**Draft Comments on the *Final Proposed Plan For LHAAP-16*
Longhorn Army Ammunition Plant, Karnack, Texas, September 2010**

George Rice
November 1, 2010

These comments are submitted on behalf of the Caddo Lake Institute. They are based on an evaluation of the *Final Proposed Plan For LHAAP-16*¹, as well as supporting documents (see references).

Figure 1

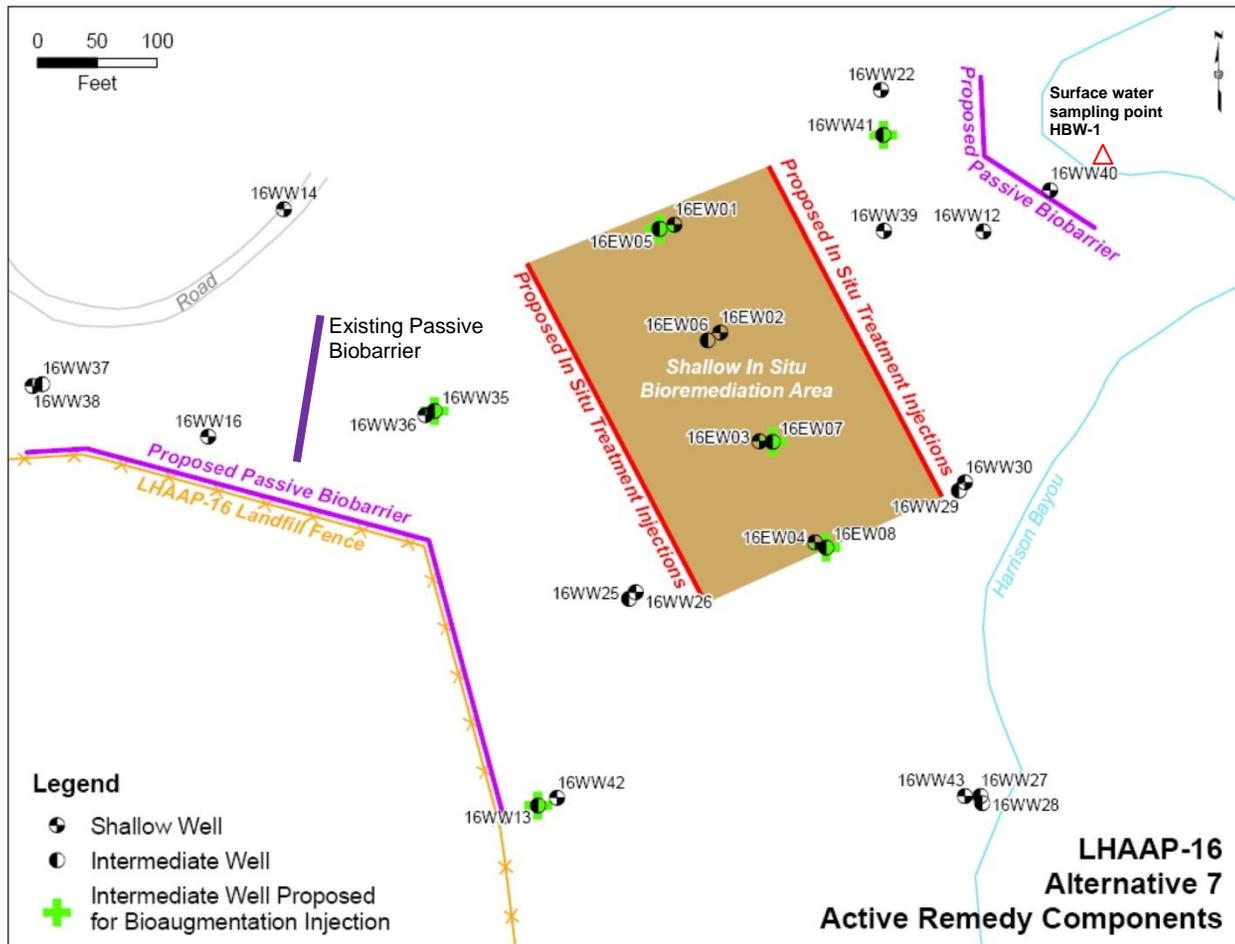
The proposed monitor well network will not detect contaminants that flow to the southeast of the down gradient barrier (see figure 1). The Army should install at least one shallow and one intermediate monitor well between the southeast end of the barrier and Harrison Bayou.

The proposed monitor well network does not include an intermediate monitor well between the down gradient barrier and Harrison Bayou. The Army should install an intermediate monitor well next to well 16WW40 (see figure 1).

The proposed monitor well network will not detect contaminants that flow thorough the northern portion of the down gradient barrier (see figure 1). The Army should install at

least one shallow and one intermediate monitor well between the northern portion of the barrier and Harrison Bayou.

The extent of the contaminant plume in the shallow aquifer north of well 16WW22, and in the intermediate aquifer north of well 16WW41, is unknown⁸². The Army should install at least one shallow well and one intermediate monitor well to the north of these wells (see figure 1).

The Army is proposing only one sampling point on Harrison Bayou near site 16 (see figure 1). Thus, if contaminants are detected, the Army will not be able to determine whether they are coming from site 16 or from an upstream source. In addition, this single sampling point will not detect any site 16 contaminants that enter Harrison Bayou downstream of the point. That is, it will not detect contaminants that may flow around the northern end of the biobarrier, or through the barrier if it fails to function as intended.

The Army should monitor at least two additional sampling points near site 16. One point should be immediately upstream of the site, and one should be immediately downstream of the site.
